# Access Compliance Report

## Public Rights-of-Way

Intersection ID: 12877	Main Street: E_5TH_ST	Cross Street: N_MYERS_ST	Location: E
ADA ID: 63A04254CF	Ramp Type: PerpDiag	Initial Pass/Fail: Fail	Overall Compliance: No
			Severity Score: 26.25

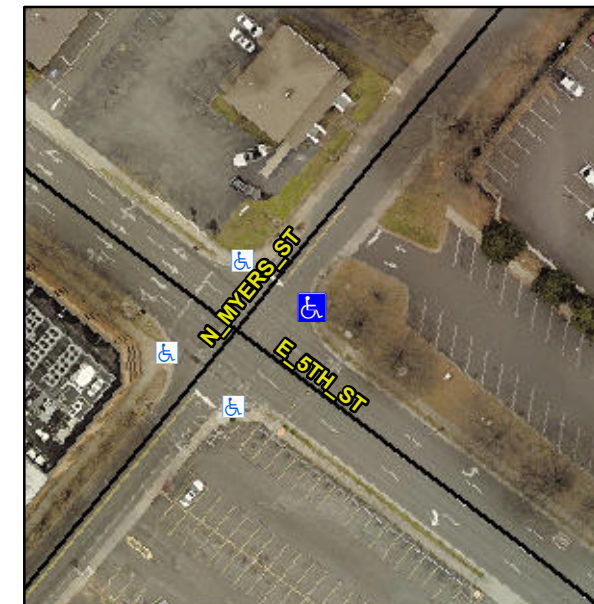
**Not Found, R304.2.2, R304.5.3**

Compliance	Description	Data	Compliance	Description	Data
N/A	Ramp Length (in)	59.0	No	Ramp Slope (%)	12.9
Yes	Ramp Width (in)	48.0	No	Ramp XSlope (%)	4.0
N/A	Flare Type LT	N/A	N/A	Flare Type RT	N/A
N/A	Flare Slope LT (%)	N/A	N/A	Flare Slope RT (%)	N/A
N/A	Flare Traversable LT?	N/A	N/A	Flare Traversable RT?	N/A
N/A	Landing Length (in)	N/A	N/A	DWS Provided?	N/A
N/A	Landing Width (in)	N/A	N/A	DWS Contrast?	N/A
N/A	Landing Slope (%)	N/A	N/A	DWS Length (in)	N/A
N/A	Landing X Slope (%)	N/A	N/A	DWS Full Width?	N/A
N/A	Landing Curb? (Y/N)	N/A	N/A	DWS Offset (in)	N/A
N/A	Shared Landing?	N/A			
N/A	Gutter Ponding?	N/A	N/A	Gutter Slope (%)	N/A
N/A	Gutter Lip Ht (in)	N/A	N/A	Gutter X Slope (%)	N/A
N/A	Painted X Walk1?	No	N/A	Painted X Walk2?	No
	X Walk 1 Direction	To NW		X Walk 2 Direction	To SW
N/A	X Walk 1 Width (in)	N/A	N/A	X Walk 2 Width (in)	N/A
	X Walk 1 Slope (%)	10.2		X Walk 2 Slope (%)	5.3
	X Walk 1 X Slope (%)	1.5		X Walk 2 X Slope (%)	6.7

**Remove & Replace Curb Ramp With Two New Directional Ramps or Equivalent.**
